66309B-521-03

S E R V I C E N O T E

66309B with Option #521

Reliability Improvement of Instrument

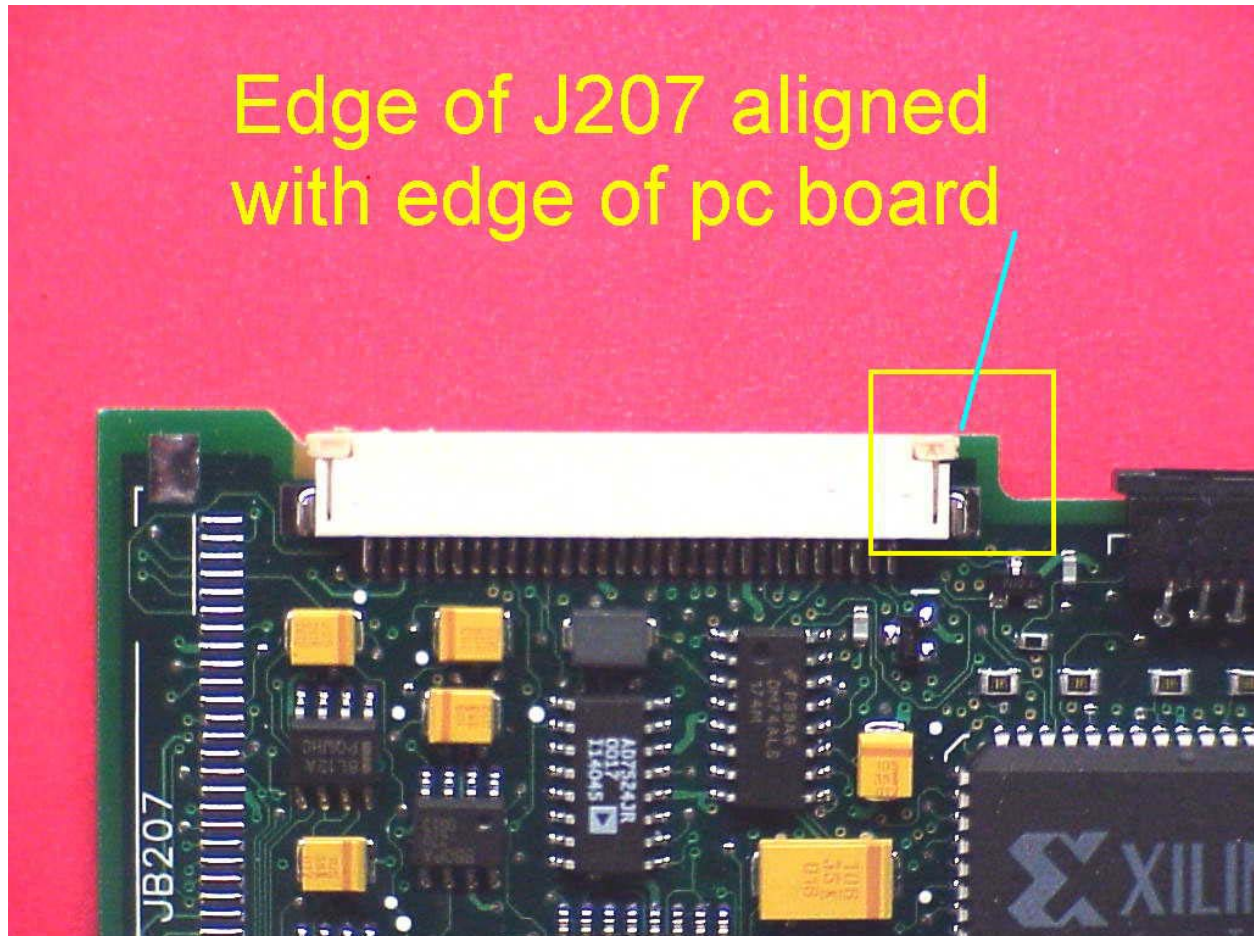
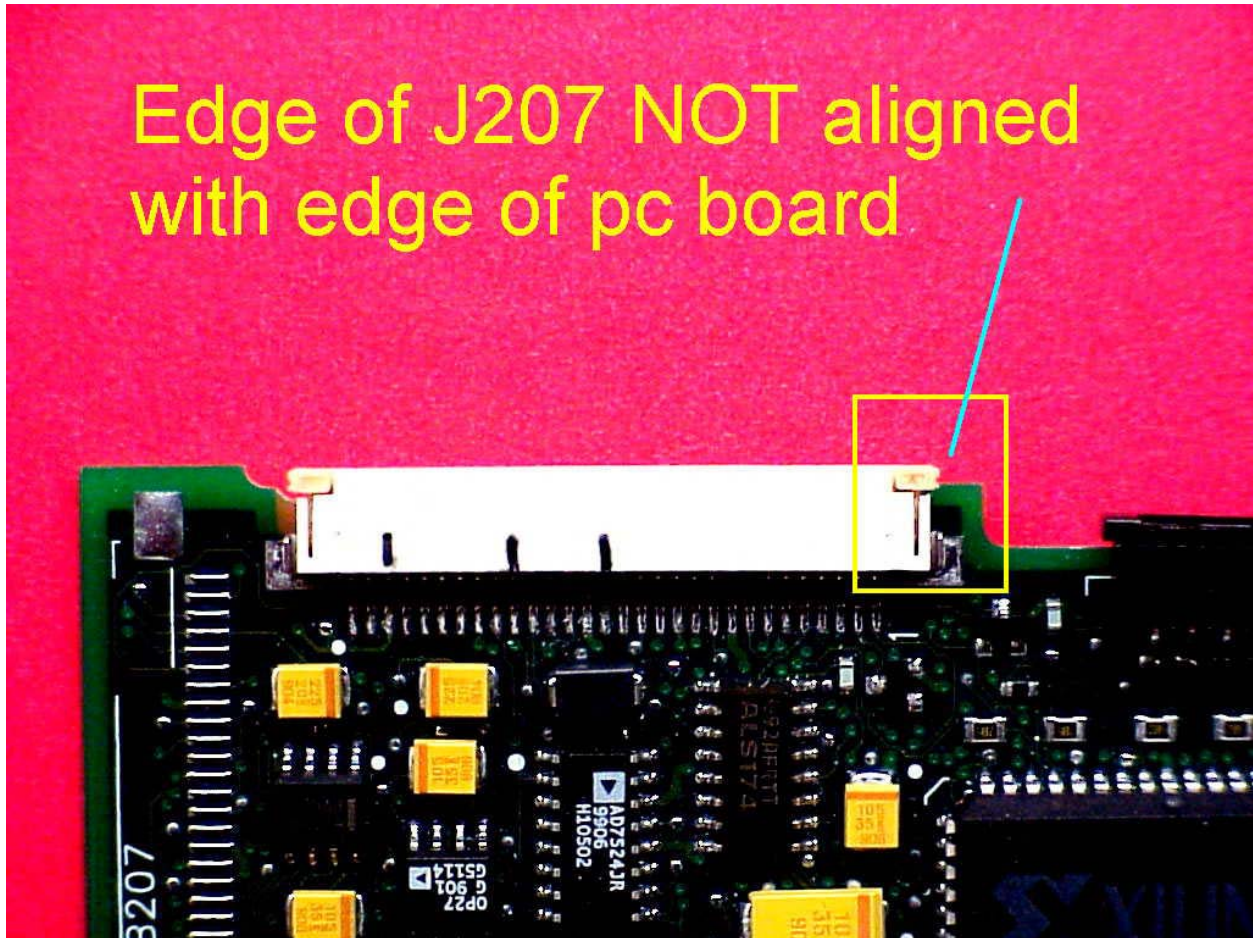
Latent product failure due to misplaced connector J207 on SMT assembly 5064-0018 (GPIB/RS232 interface). Misplacement of J207 could lead to inadvertent contact/shorting of exposed feed-throughs on SMT board. Ultimately, resulting in over-stress of components of damage to SMT board components. Resulting contact could degrade useful life of instrument.

CORRECT J207 PLACEMENT – alignment to within $< 0.3\text{mm}$

Picture shows connector aligned to edge of SMT board to within $< 0.1\text{mm}$

INCORRECT J207 PLACEMENT – misaligned by $> 0.3\text{mm}$

Picture shows connector extending past edge of SMT board by $>1.2\text{mm}$

- 1) Compare placement of J207 to attached photos. Instruments with a “misplaced” J207 should be returned to Agilent for warranty repair.
- 2) Instruments returned to the Service Center for routine calibration should be inspected for this potential defect. Defects should be addressed using Agilent’s unit exchange process with costs being charged to warranty.
- 3) The factory has modified production documentation to include visual inspection and specific electrical testing for this potential short.
- 4) Factory is maintaining feedback to SMT board supplier regarding quality of assembly.
